# BODY

## 7 SEAT CHUCKING (1958 Thunderbird)

Fig. 1 - Seat Chucking Correction (Item 7)

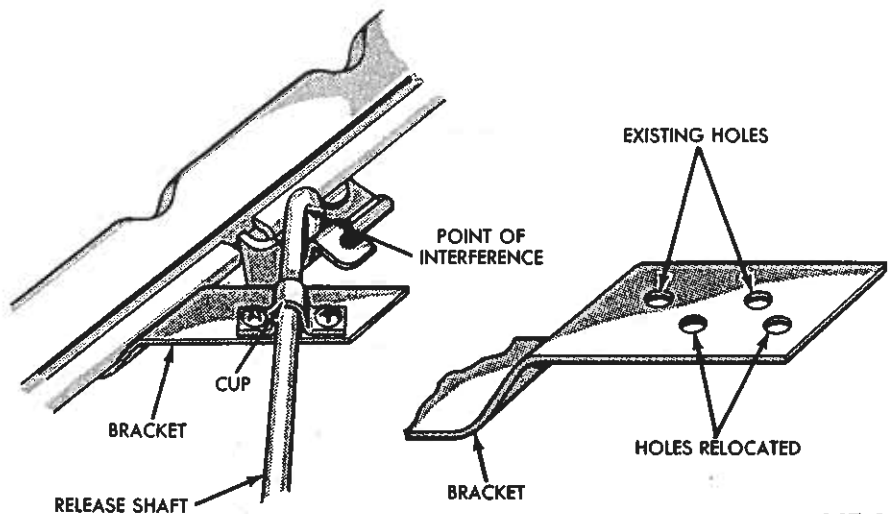
Seat chucking on the 1958 Thunderbird is caused primarily by:

1. Loose seat track attaching bolts.
2. Improper engagement of the locking pawl at the seat track.

Some early production 1958 Thunderbirds have a mislocated clip securing the lock release shaft (Fig. 1). This causes the shaft to bind against the seat track. If bending the tab does not correct the bind, it will be necessary to relocate the clip on the tab (Fig. 1).

These conditions can be corrected by removing the seat assembly and tightening all of the attaching bolts securely, particularly the seat track to seat cushion frame bolts.

Then, operate the release lever and observe if the locking pawl engages completely into the slots on the seat track. If complete engagement is not obtained, it will be necessary to align the release lever shaft by bending the tab nearest the seat track. This tab should be bent slightly up or down until free movement of the release lever shaft is obtained and the pawl completely engages the slots in the seat track.

Fig. 2 - Deck Lid Bumper Installation (Item 10)

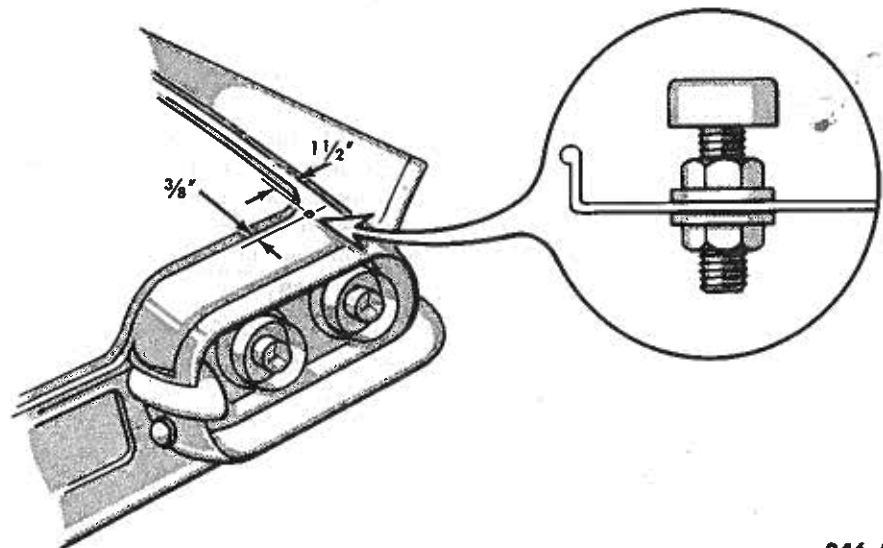
Excessive flexing at the rear corners of the 1958 Thunderbird deck lid can be corrected by adding a rubber bumper (B5A-16769-A) at each rear corner as follows:

1. Remove the trim panels from the rear surface of the luggage compartment. Locate and drill a 3/8" diameter hole at each rear corner as shown in Fig. 2.

2. Install an adjustable rubber bumper (B5A-16769-A) with a flat-washer on both sides of the sheet metal and secure each of the bumpers in place with the two hex-head nuts (Fig. 2).

3. Adjust the height of the rubber bumpers to obtain a flush fit of the deck lid and the quarter panel surfaces.
